Re: GLOUCESTER – Solid Waste Management
Eastern Waste Services, LLC
24 Kondelin Road
FMF#: 364665

BWP SW01/Site Suitability for a New Site Assignment
Application Number: 23-SW01-0002-APP

On behalf of Eastern Waste Services (EWS), Tetra Tech is responding to MassDEP technical review comments received in regard to the Site Assignment Application #23-SW01-0002-APP (Application).

PROPOSED CONDITIONS PLAN

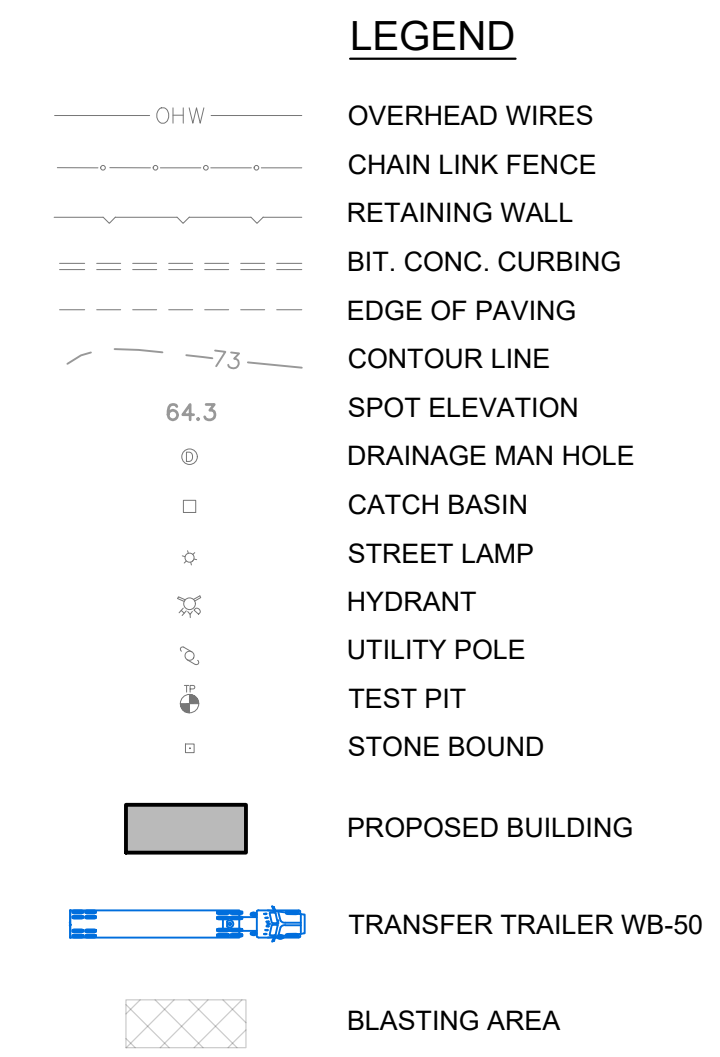
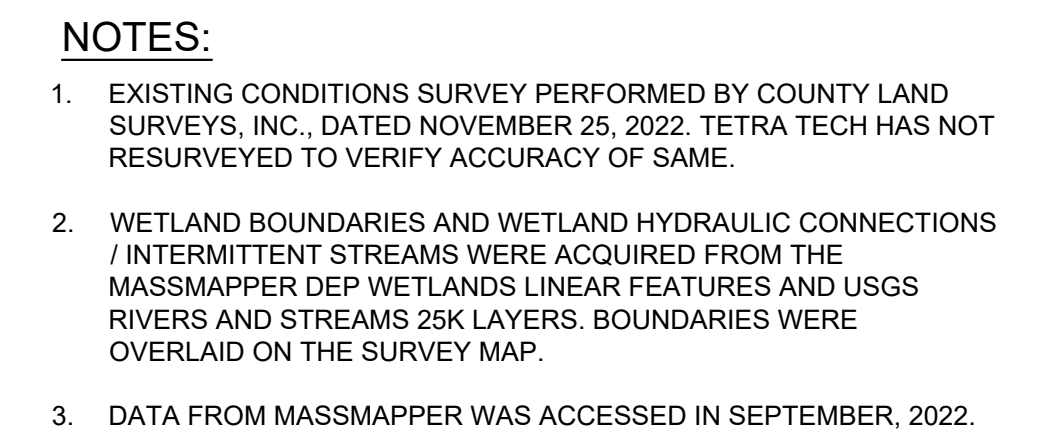
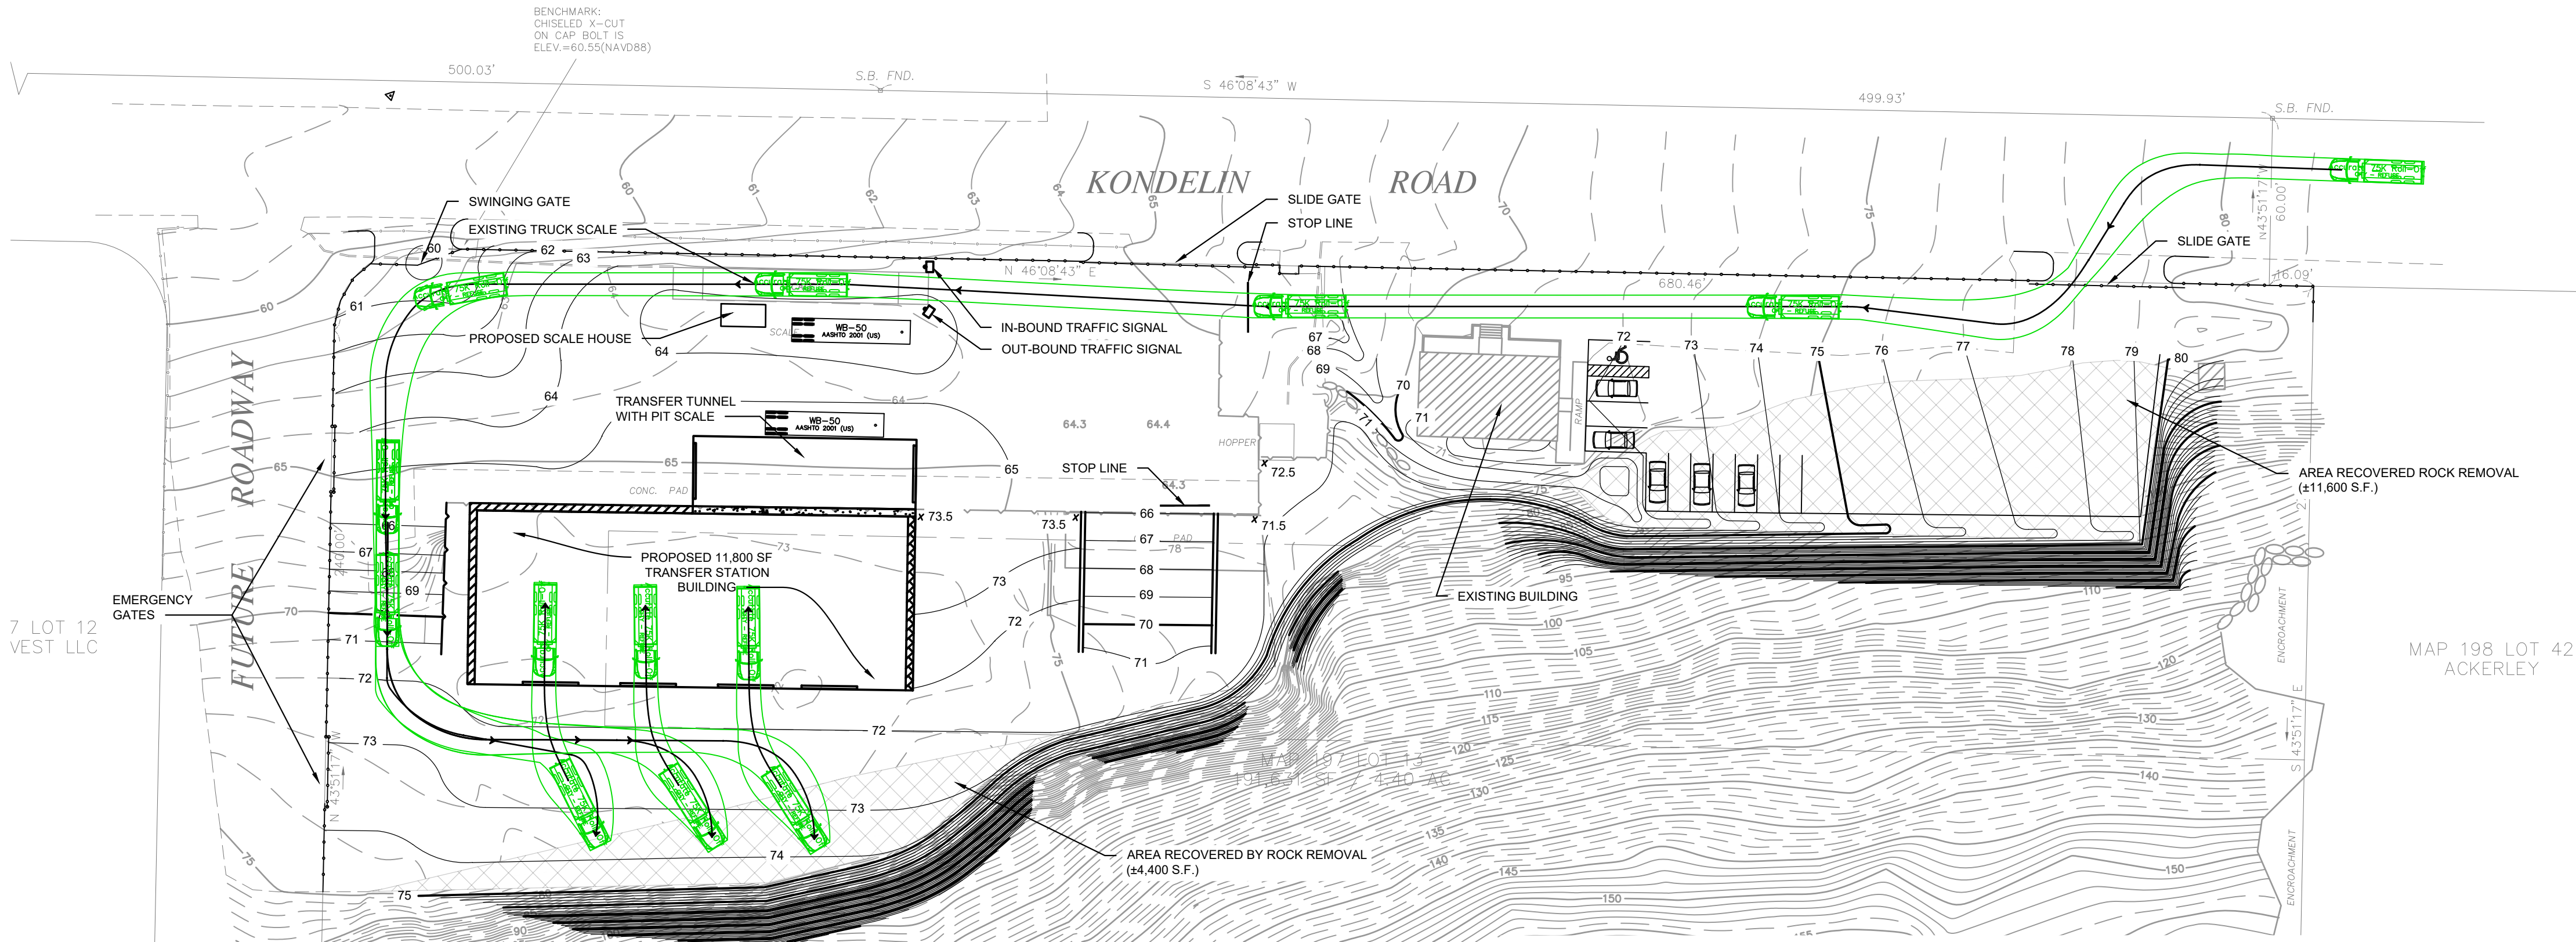
Please find attached revised conceptual site plans that show the smaller transfer building and layout. The primary facility vehicle entrance, which will be used by all customers and EWS vehicles bringing C&D waste material to the site, is now located in the northern corner of the site and allows for a one-way traffic flow pattern around the proposed transfer building. The northern entrance also provides sufficient queuing for more than four (4) delivery trucks on the approach to the scale in addition to additional queuing space between the scale and the ramp up to the proposed transfer building. The primary facility exit for all customers and EWS vehicles bringing C&D waste material to the site will be located in the western corner of the site, just southwest of the existing truck scale.

Transfer trailers will enter the site from the western corner, be weighed using a separate pit scale located in the transfer tunnel and exit through a dedicated exit located at about the mid-point between the western and northern corners, just northeast of the existing scale.

The revised conceptual site plans in Attachment B call for a reduced transfer station facility size of 11,800 square feet that will receive and transfer only 270 TPD of C&D waste material. Only C&D waste material will be accepted for transfer. No MSW will be accepted. The new facility size will allow for better exterior vehicle circulation, access, and egress. The Facility will operate up to 6 days per week, 12 hours per day.

FIRE TRUCK
TURNING MOVEMENT PLAN

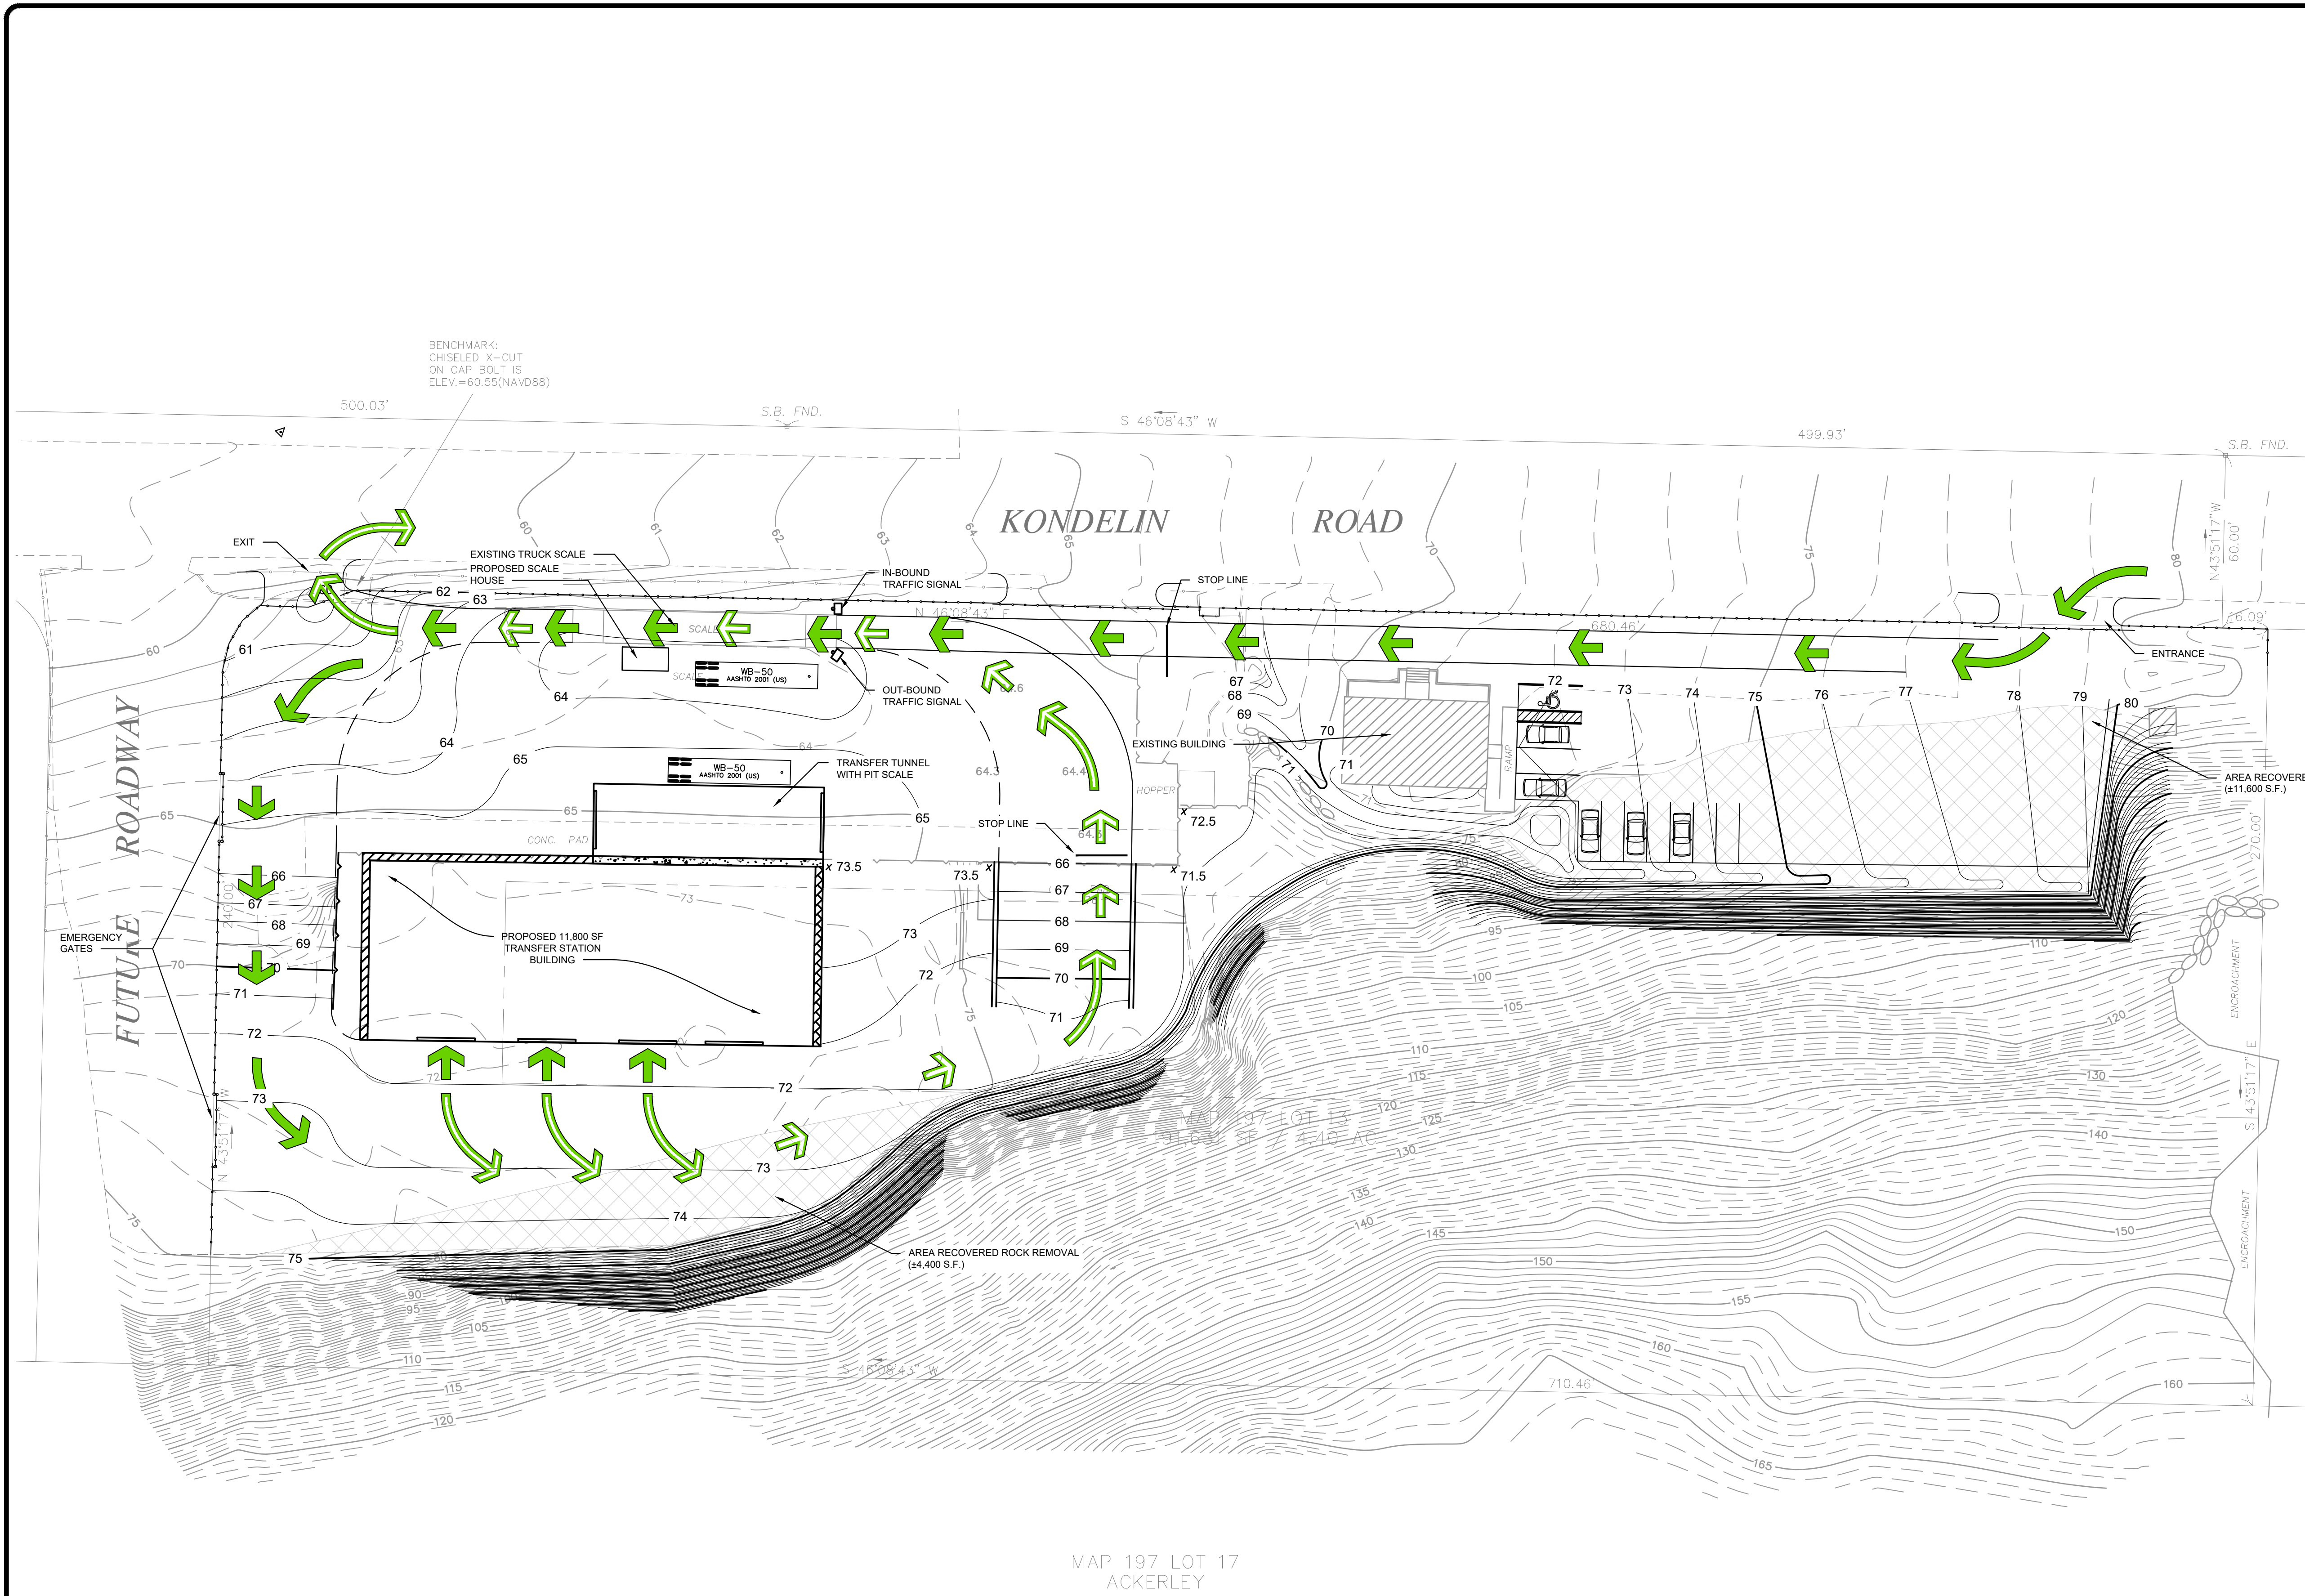
The Proponent is also intending to remove 4,400 square feet of ledge from behind the transfer station building to allow vehicles to more easily access the building and allow for the city's largest fire truck to have complete access around the building. Because this material is competent ledge, there is little existing infiltration of stormwater. The proposed condition will direct stormwater to catch basins that will be connected to oil/water and particle separators. The proposed stormwater management system will be subject to the Gloucester Conservation Commission review and approval. Additional ledge will be removed from the northeast corner of the site. This side of the property is not part of the transfer station operations and is not included in the transfer station site assignment area.
